31/07-03D 10 Post Office Road  
(Capitol View Historic District)

HISTORIC AREA WORK  
PERMIT

SUBJECT: Historic Area Work Permit 31/07-03D DPS# 308024

**HISTORIC PRESERVATION COMMISSION STAFF REPORT**

WEST ELEVATION

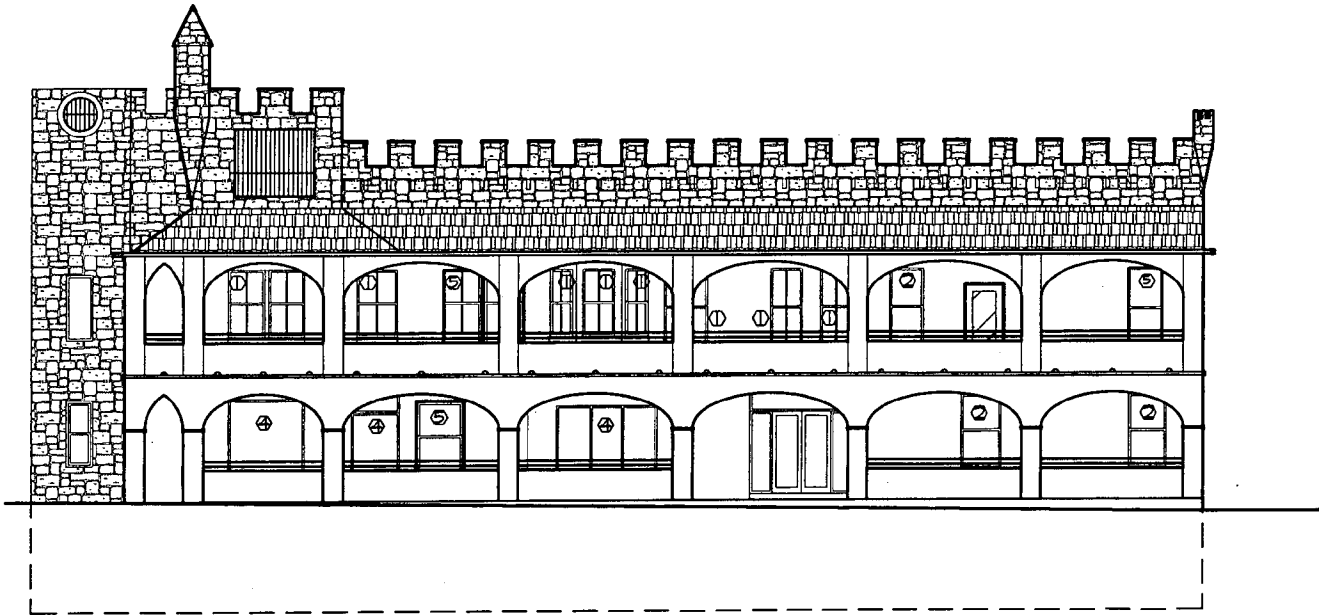
The intent of the window replacement along the South and West elevations is to recover these elevations to its original stage. At present we have a mix beg of window from wood to vinyl double hungs to aluminum store front.

Without a condition assessment of each historic window, staff recommends that the applicant save all of the historic windows (noted as "1" on the window schedule. Staff feels that it is appropriated to replace the windows that are non-historic with new wood 2/2 double-hung windows (non-historic windows are noted as "2" and "3" on the window schedule.)

In terms of the existing storefront windows (noted as "4" on the window schedule), staff feels that additional research should be done to determine if these windows are historic or not. The

1. Only the non-historic windows shall be replaced. These include the windows noted as "2" or "3" on the window schedule provided by the applicant.
2. The replacement windows will be wood, 2/2, true-divided lite, double hung windows. The original mullion thickness will be duplicated on the replacement windows.
3. Storm windows may be applied for sound protection.
4. The applicant may return to the HPC with more information about the historicity of the storefront windows, if they wish to argue for replacement of them.
